Access Compliance Report Public Rights-of-Way (Curb Ramps)

Main Street: RAINIER_DR Cross Street: BOW_PL Location: NW

ADA ID: RPAT211022151104 Ramp Type: Type 1 - Perpendicular Diagonal Initial Pass/Fail: Pass Overall Compliance: No Severity Score: 22

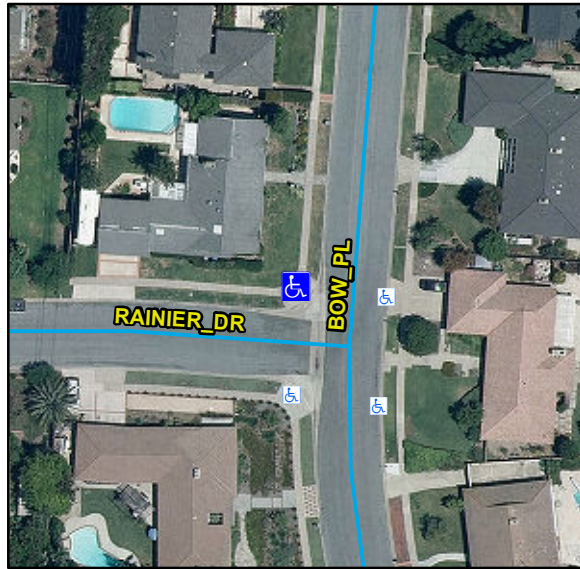
Compliance	Description	Data	Compliance	Description	Data
N/A	Ramp Length (in)	130	N/A	Flare Type LT	
Yes	Ramp Width (in)	51			Sloped
Yes	Ramp Run Slope (%)	7.2	N/A	Flare Slope LT (%)	6.1
Yes	Ramp Cross Slope (%)	0.6	N/A	Flare Traversable LT	No
N/A	Landing Present	No	N/A	Flare Type RT	
N/A	Landing Length (in)	N/A			Sloped
No	Landing Width (in)	N/A	N/A	Flare Slope RT (%)	4.1
No	Landing Run Slope (%)	N/A	N/A	Flare Traversable RT	No
No	Landing Cross Slope (%)	N/A	No	DWS Provided	No
N/A	Landing Movement Obstructed?	No	N/A	DWS Contrast	N/A
	Landing Movement Type	N/A	N/A	DWS Length (in)	N/A
N/A	Landing Shared	N/A	N/A	DWS Full Width	N/A
N/A	Clear Space	Yes	N/A	DWS Offset Left (in)	N/A
N/A	Clear Space To Crosswalk (in)	48	N/A	DWS Offset Right (in)	N/A
N/A	Marked Crosswalk 1	No	N/A	Marked Crosswalk 2	No
	Crossing 1 Direction	S		Crossing 2 Direction	E
	Marked Crosswalk 1 Width (in)	N/A		Marked Crosswalk 2 Width (in)	N/A

N/A	Ramp Inside Crosswalk 1	N/A	Yes	Ramp Inside Crosswalk 2	N/A
	Crossing 1 Slope (%)	2.4		Crossing 2 Slope (%)	5.6
	Crossing 1 Cross Slope (%)	1.6		Crossing 2 Cross Slope (%)	1.2
Yes	Gutter Ponding	No	No	Curb Slope	7.8
Yes	Gutter Lip Height (in)	0		Road Run Slope (%)	0.1
Yes	Gutter Run Slope (%)	3.4		Road Cross Slope (%)	1.6
Yes	Gutter Cross Slope (%)	0.4			
Yes	Overall Surface Condition: Acceptable		No	Perp Joint Present	No
	Cross Gutter Present?	Yes		Spandrel Present?	Yes
	Replace Cross Gutter?	No		Replace Spandrel?	No

Remove & Replace Curb Ramp With Two New Directional Ramps or Equivalent.
